# LAKE HAVASU CITY, ARIZONA

## ADDENDUM NO. 1

### Lake Havasu & Mesquite Avenue Paving Rehabilitation

Project No: B25-PW-106017-500586

**WATER PLAN & PROFILE**  
**- MESQUITE AVE STA**  
**166+00 TO 170+50**

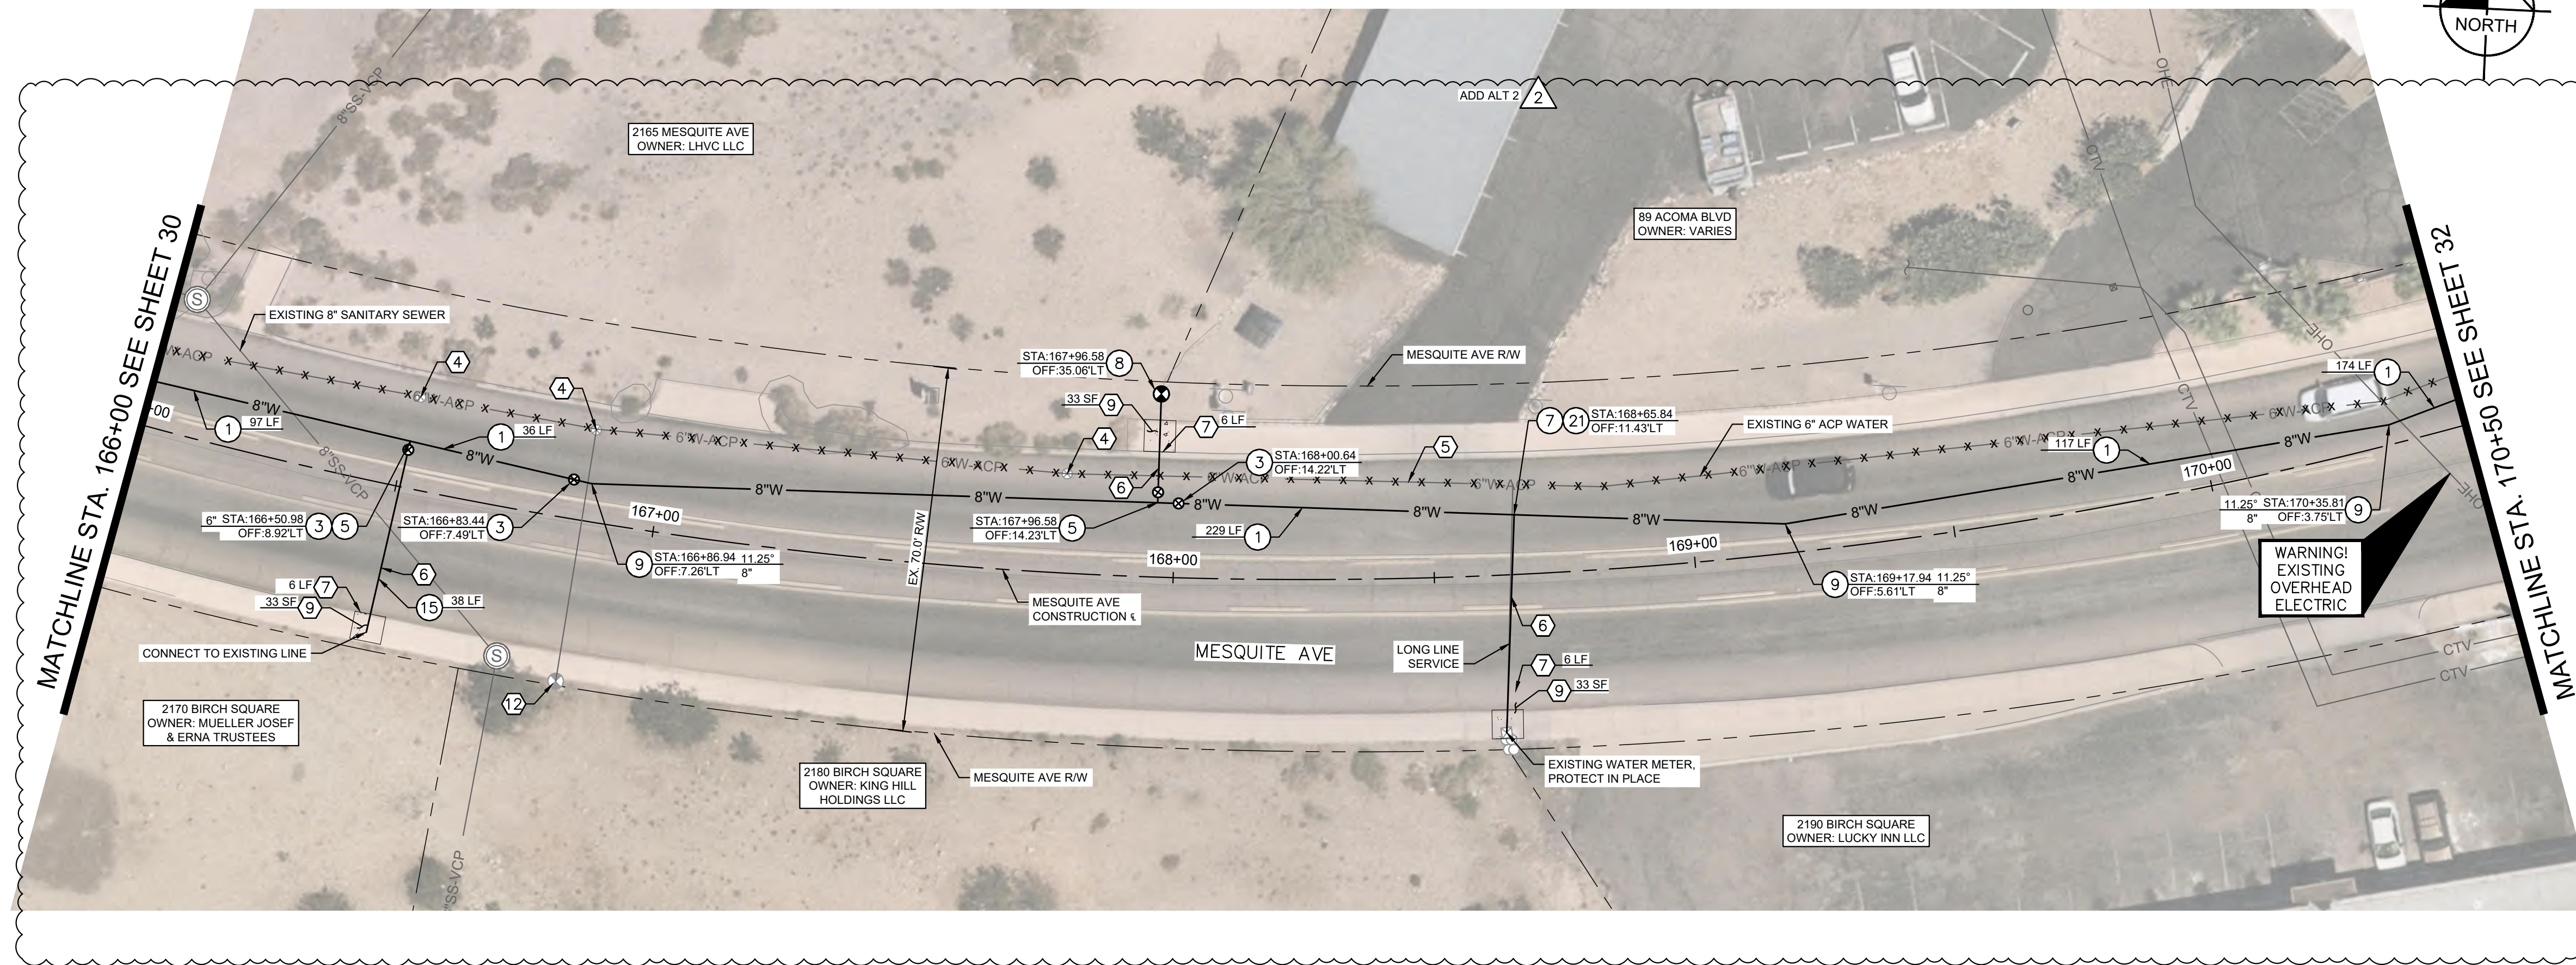
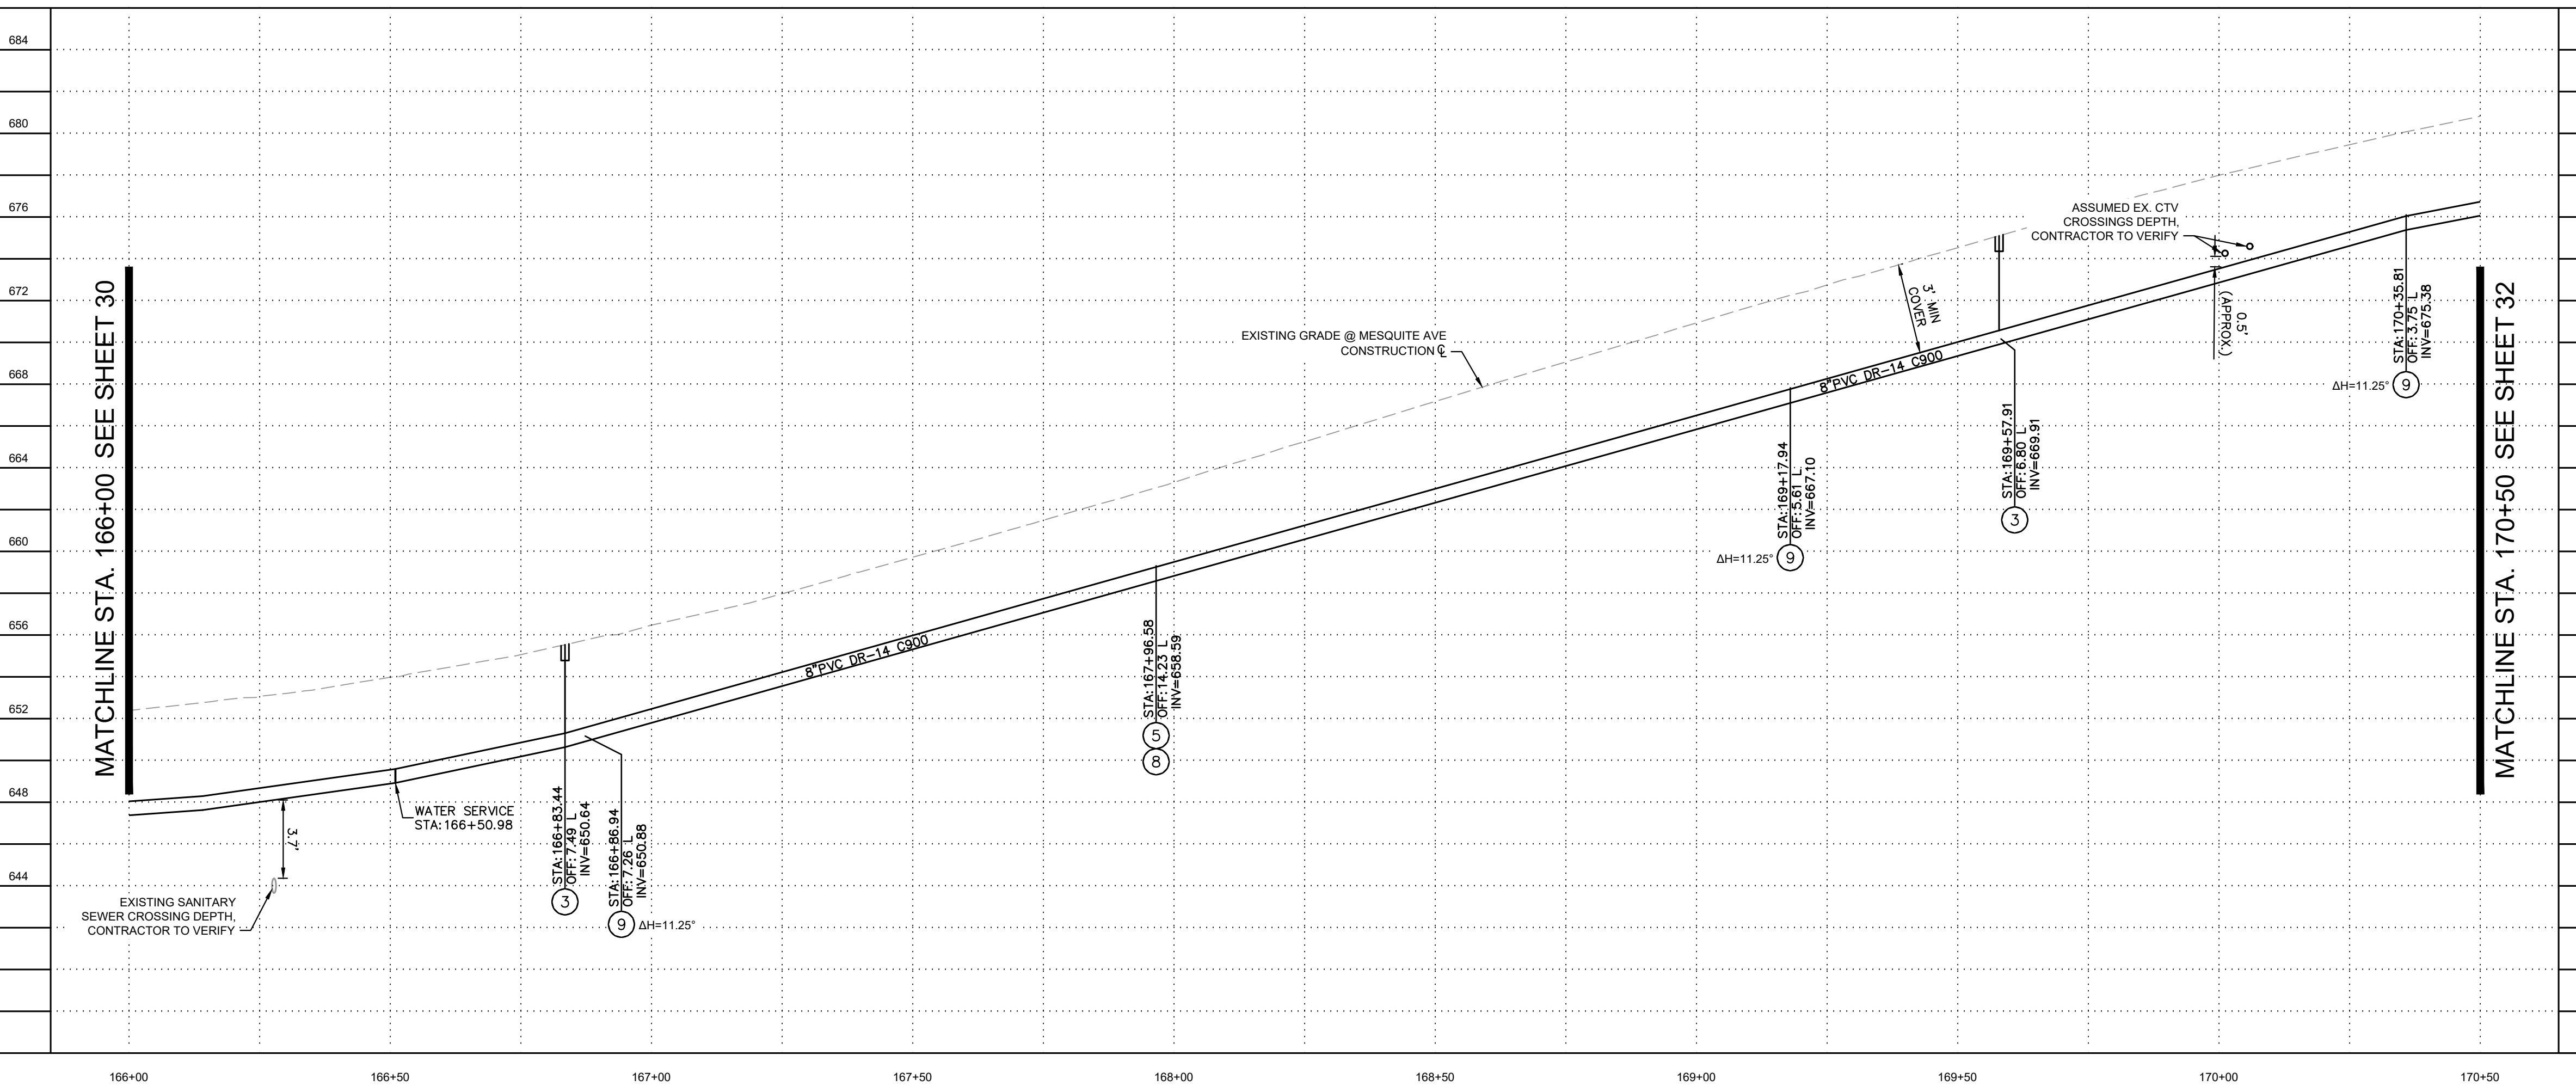
- Improvements have been identified as part of Bid Alternate 2.

2 ADD ALT 2 REMOVE WATER MAIN IMPROVEMENTS MESQUITE AVENUE, PIMA WASH TO ACOMA BLVD.

NO.	REVISIONS / SUBMISSIONS	DATE
2	BID ALTERNATE 2	10/29/2024
#	-	-
#	-	-
#	-	-

**WATER PLAN & PROFILE**  
**- MESQUITE AVE STA**  
**170+50 TO ACOMA BLVD**

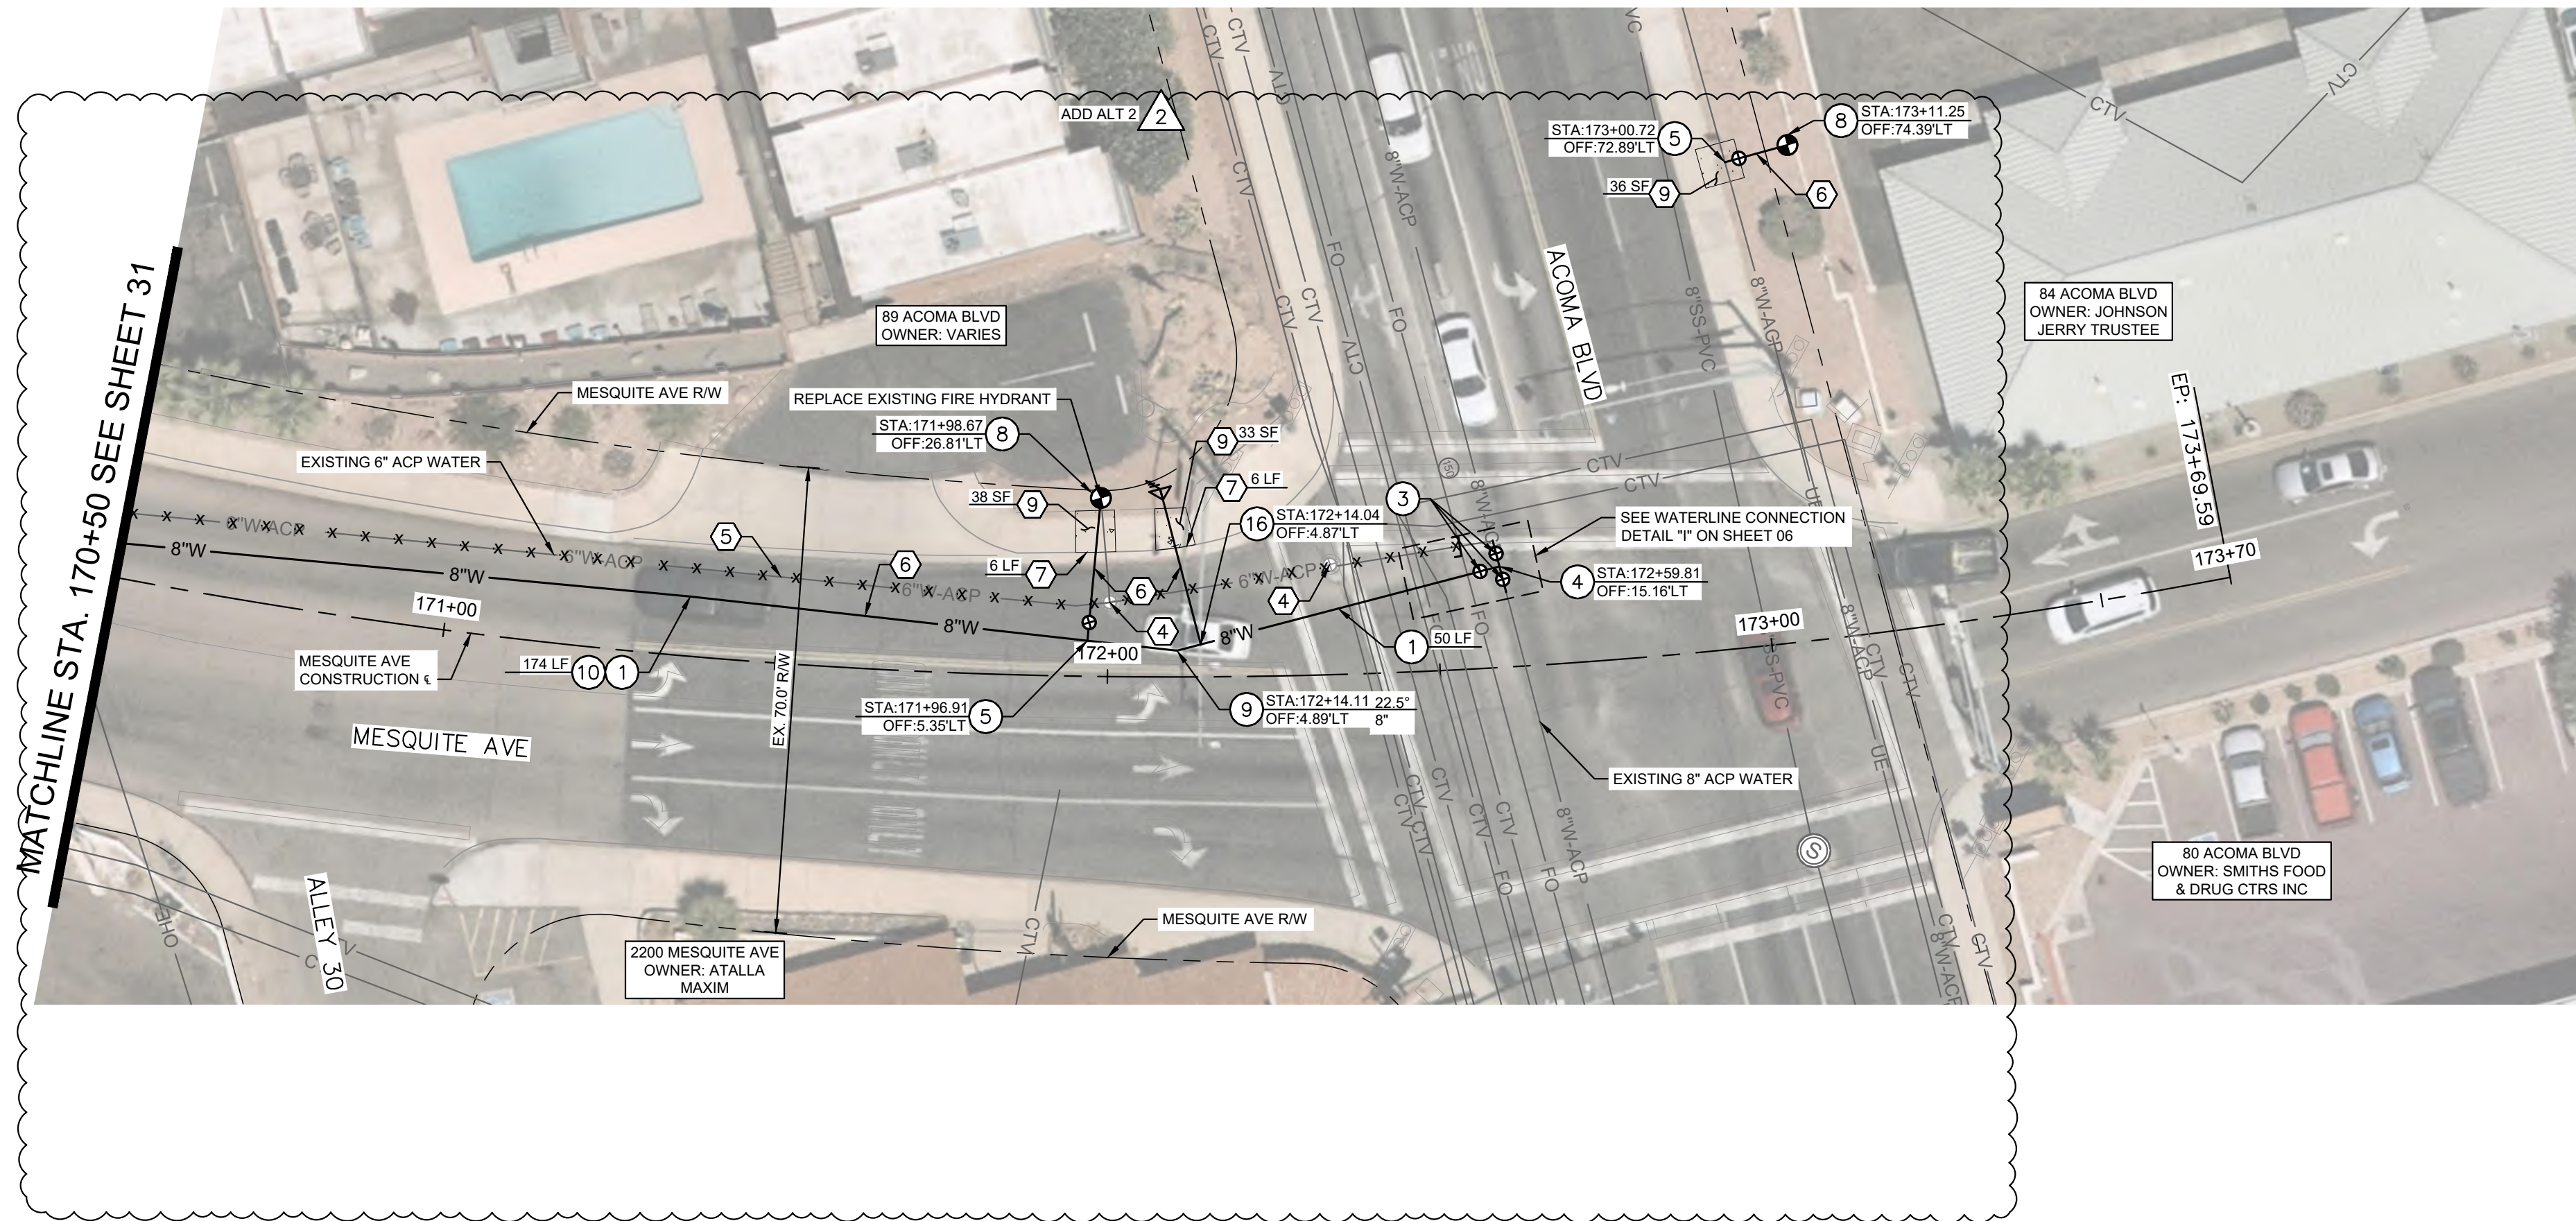
2 ADD ALT 2 REMOVE WATER MAIN IMPROVEMENTS MESQUITE AVENUE, PIMA WASH TO ACOMA BLVD.

NO.	REVISIONS / SUBMISSIONS	DATE
2	BID ALTERNATE 2	10/29/2024
#	-	-
#	-	-
#	-	-
